# HISTORIC AND DESIGN REVIEW COMMISSION

May 29, 2020

**HDRC CASE NO:** 2020-191  
**ADDRESS:** 320 N HACKBERRY ST  
**LEGAL DESCRIPTION:** NCB 584 BLK W 1/2 7 LOT 5 ARB A5  
**ZONING:** RM-4, H  
**CITY COUNCIL DIST.:** 2  
**DISTRICT:** Dignowity Hill Historic District  
**APPLICANT:** Johnrudy Balderrama/JRM CONSTRUCTION LLC  
**OWNER:** Johnrudy Balderrama/JRM CONSTRUCTION LLC  
**TYPE OF WORK:** Window and siding replacement  
**APPLICATION RECEIVED:** April 24, 2020  
**60-DAY REVIEW:** Not applicable due to City Council Emergency Orders  
**CASE MANAGER:** Huy Pham  
**REQUEST:**

The applicant is requesting a Certificate of Appropriateness for approval to:

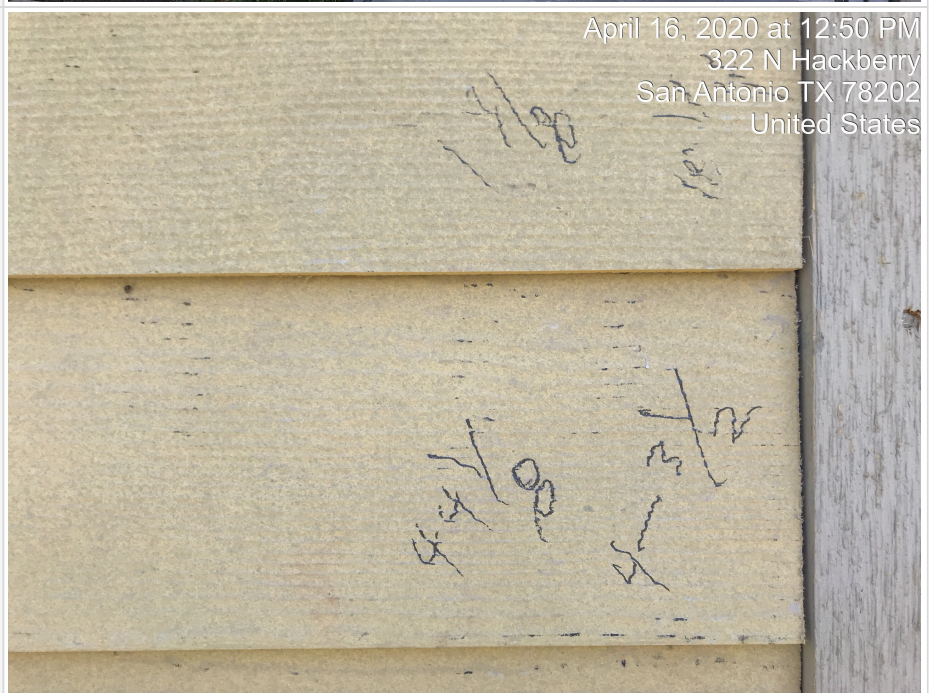
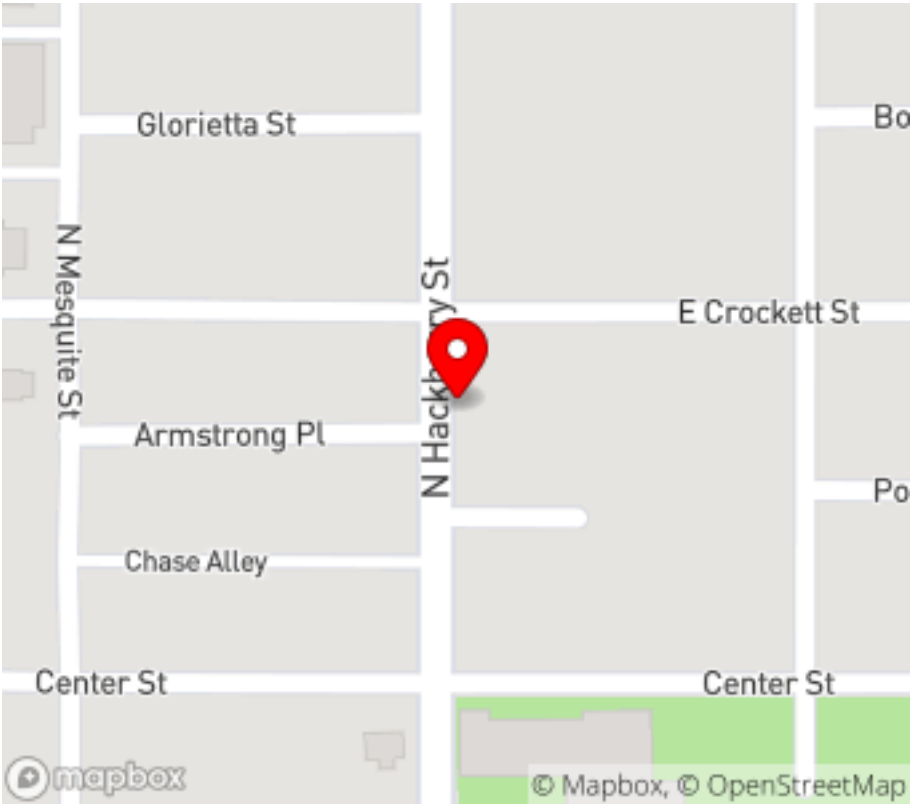
- b. COMPLIANCE – Staff posted a Stop Work Order on April 16, 2020, after finding that wood windows and siding were replaced prior to approval. Work continued, including the replacement of the last wood window and area of wood lap siding that was still intact during the first site visit. After staff posted another Stop Work Order on April 20, 2020, the applicant submitted an application and paid the post-work application fee to be heard at the next available Historic and Design Review Commission hearing.

Date	04/16/2020
Time	12:51 PM (-5 GMT)
Context	citizen report
Present Staff	Huy Pham, Edward Hall
Present Individuals	None
Contractor/Realtor Companies	JRM Construction
Types of Work Observed	Exterior Maintenance and Alterations
Amount of Work Completed	75%
Description of work	Window replacement, siding removal and replacement

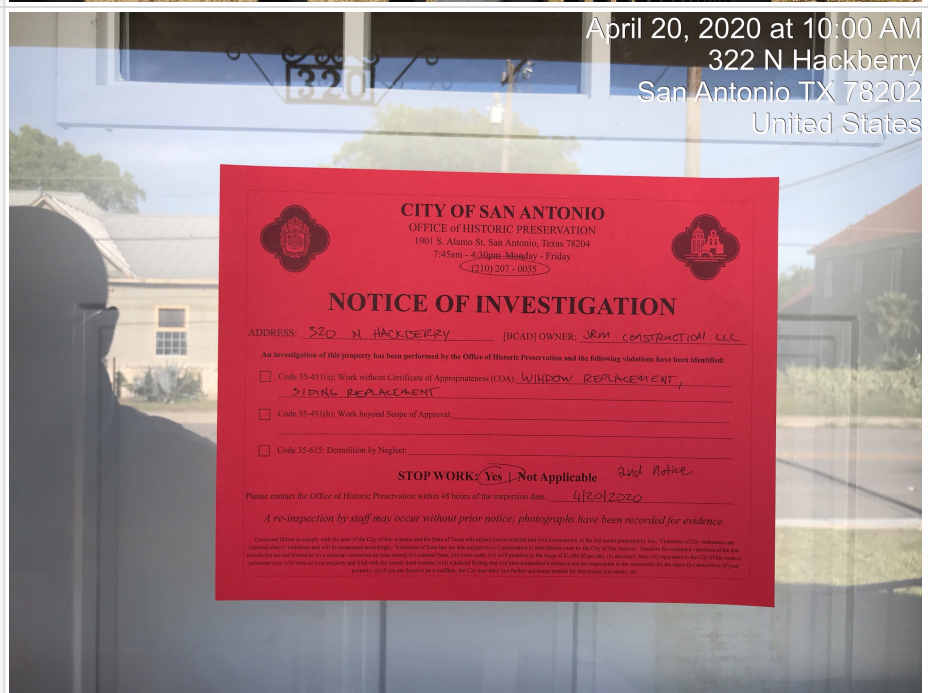
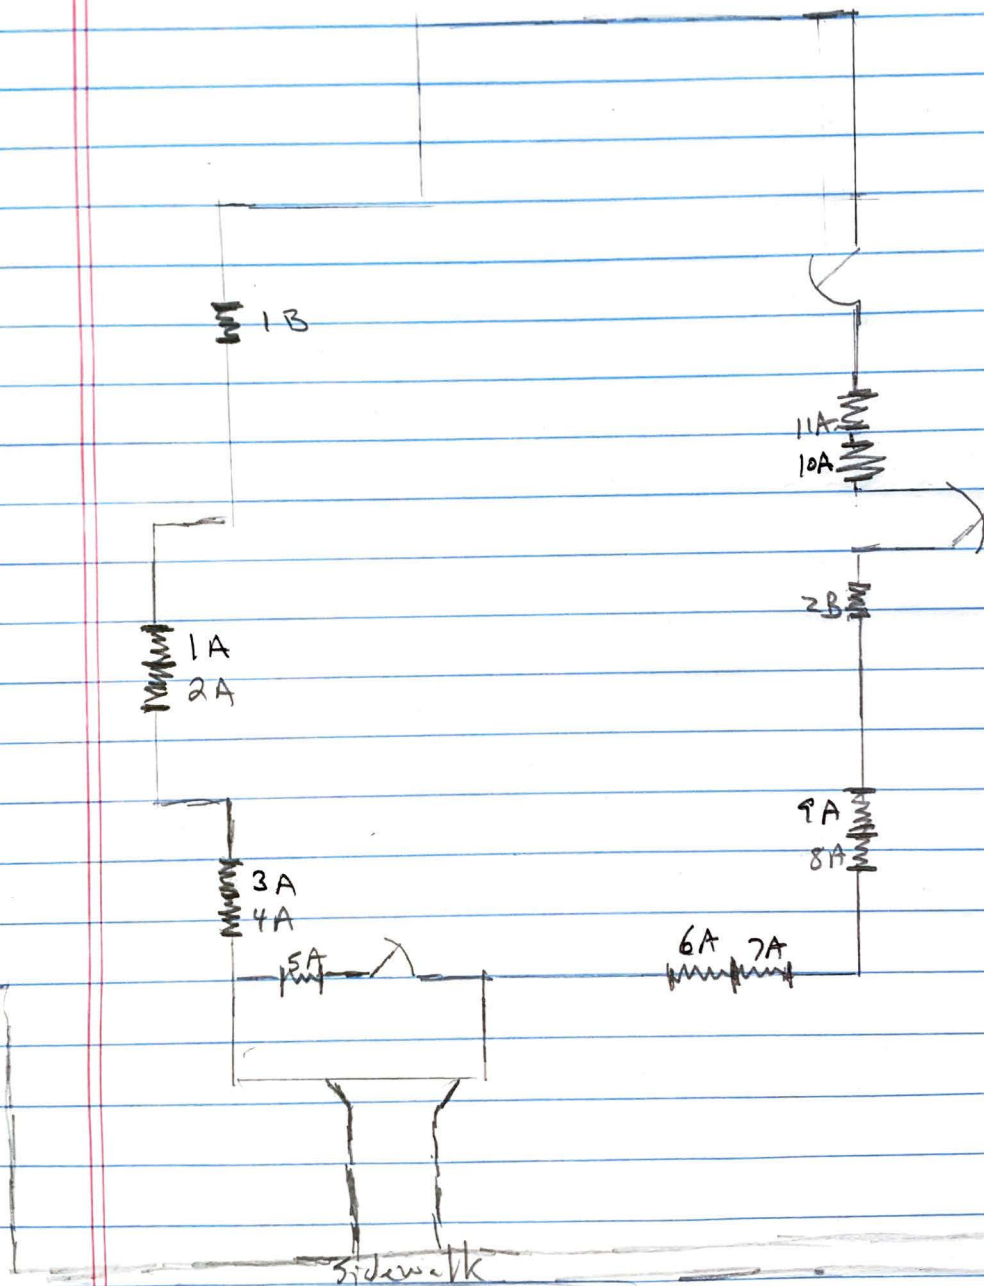
Date	04/20/2020
Time	10:02 AM (-5 GMT)
Context	citizen report
Present Staff	Huy Pham, Edward Hall
Present Individuals	None
Types of Work Observed	Exterior Maintenance and Alterations
Amount of Work Completed	75%
Description of work	More windows and siding had been replaced after first Stop Work Order.
